# XRAY XB4'15

## TIP REAR DIFF OUTDRIVES INFO

DETAIL

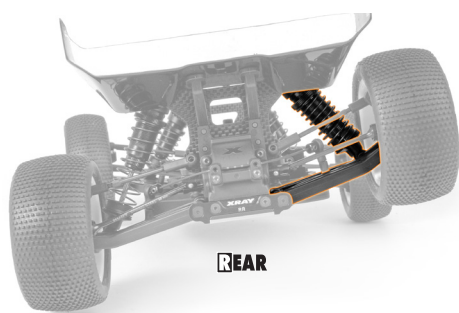
Regarding the diff outdrives, these were updated to improve the strength and reliability. Extra material was added to the outdrives to certain areas which shortened the opening in the outdrives. To keep the same suspension holders and not make new ones with different suspension positions it is suggested to use middle and outer positions for the suspension pins.

## TO ELIMINATE THIS WE SUGGEST FOLLOWING:
